Patent No.: 6,088,881

Title: METHOD AND APPARATUS FOR SEPARATING FOREIGN MATTER

## REQUEST FOR CERTIFICATE OF CORRECTION **UNDER 35 U.S.C. § 255**

# UNITED STATES PATENT AND TRADEMARK OFFICE **CERTIFICATE OF CORRECTION**

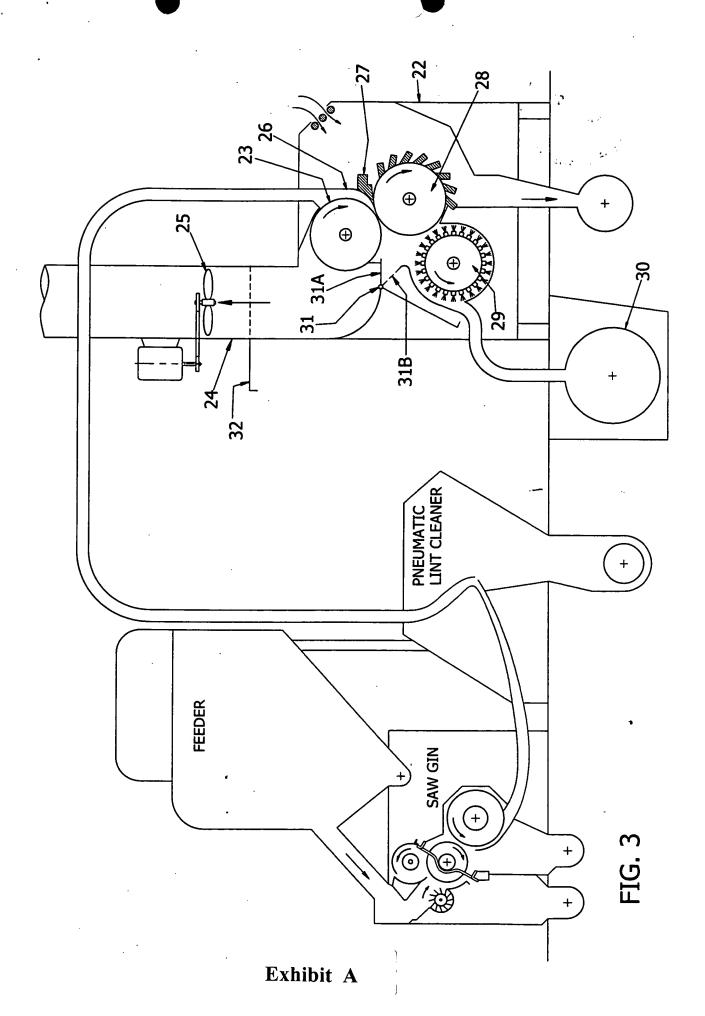
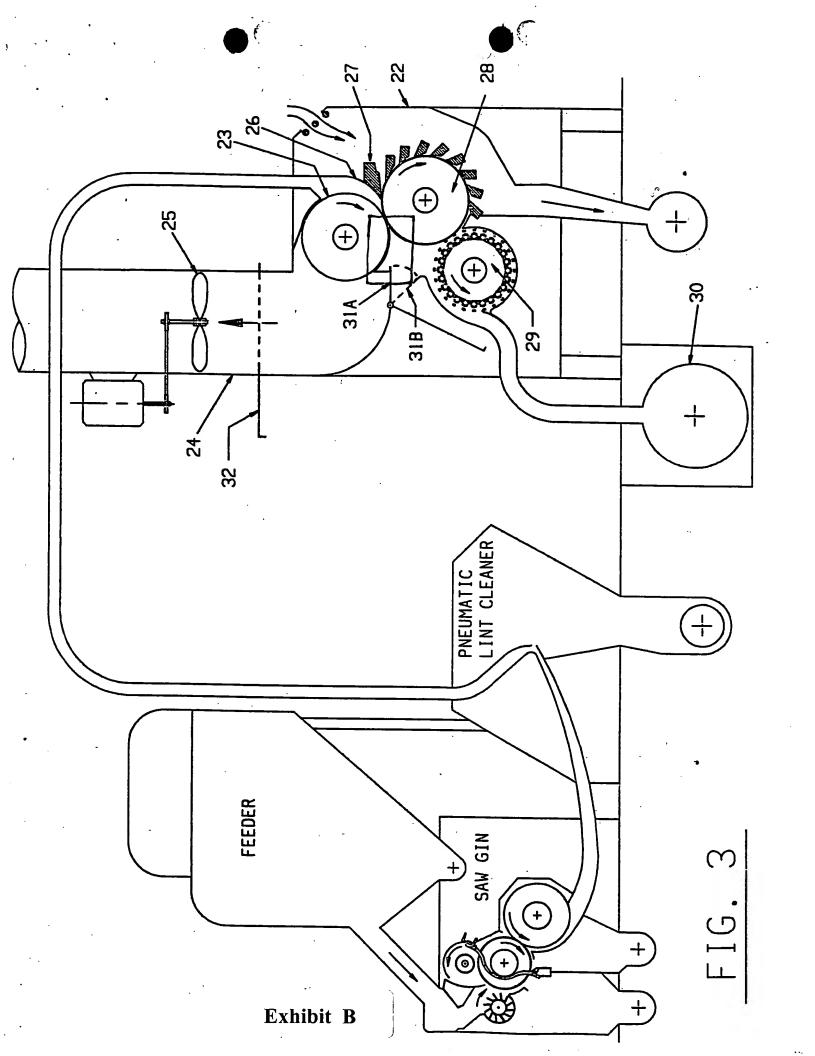
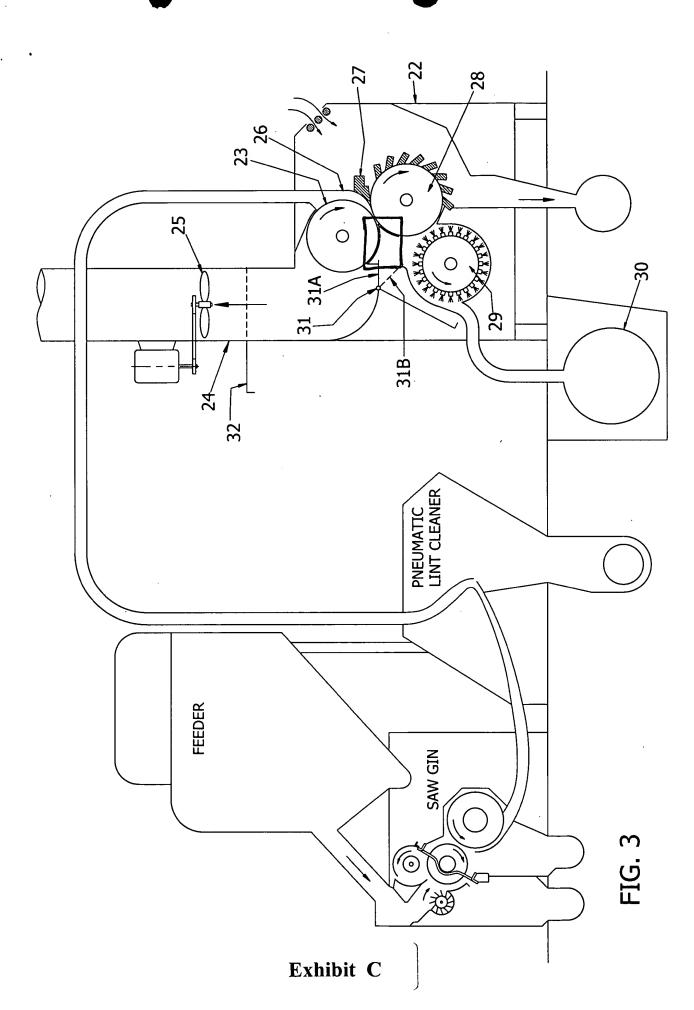
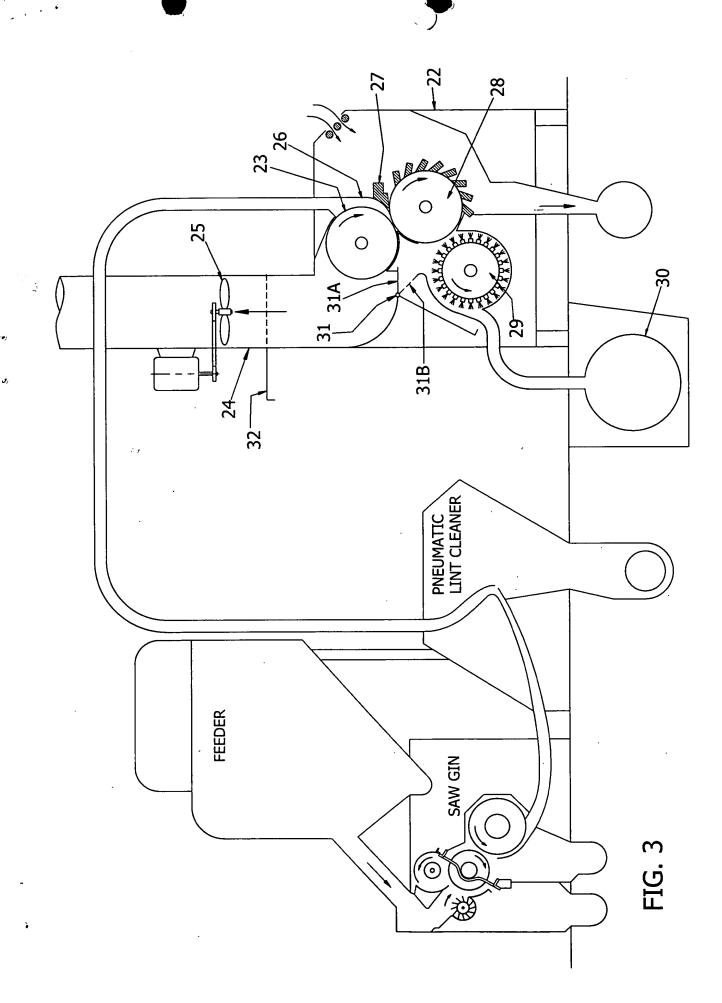
It is certified that error appears in the above-identified patent and that said Letters patent is hereby corrected as described herein. The error is found in FIG. 3 of the issued patent (a copy of this figure is submitted as Exhibit A). The error in FIG. 3 of the issued patent is that an arcuate line proximate the cylinder 23 and cylinder 28 is not illustrated as was illustrated in the original FIG. 3 filed with the initial patent application (a copy of the figure submitted with the original application is included as Exhibit B). The arcuate line that was in the original drawing is highlighted in red in Exhibit B. Consequently, the patentee provides that FIG. 3 of the issued patent contains an error since this arcuate line is missing in this illustration.

As a result of the missing line, the patentee respectfully requests that this error be corrected by reinserting the arcuate line in the formal drawing of FIG. 3, as highlighted in red in Exhibit C. As can be seen in a comparison of the original FIG. 3 of Exhibit B and the amended formal drawing of FIG. 3 in Exhibit C, the patentee requests that the arcuate line be inserted in the formal drawing of FIG. 3 (highlighted in red in Exhibit C) proximate the cylinders 23 and 28, as was originally provided in FIG 3 in the patent application when filed (see Exhibit B).

The drawing sheet consisting of figure 3 should be deleted, and substitute therefore the attached drawing sheet 3 of 3.
